*RE: Aquarion<sup>®</sup> Clip Tray Lock*

Encon suggests that the clip tray lock be removed from the Aquarion<sup>®</sup> models listed below sold prior to November 11, 2014.

FIG. 1 – Location of Clip Tray Locks

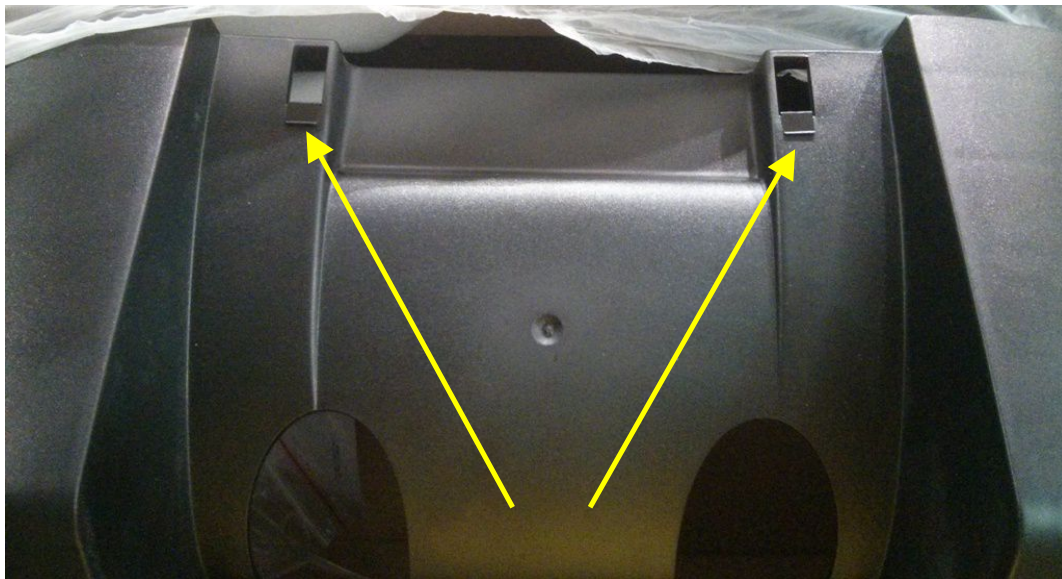
Remove the clip tray lock to allow the tray to open more smoothly and the piercing tube to fully engage the Aquarion fluid cartridges. The clips are located where the eye wash tray engages with the shell base, see figure 1.
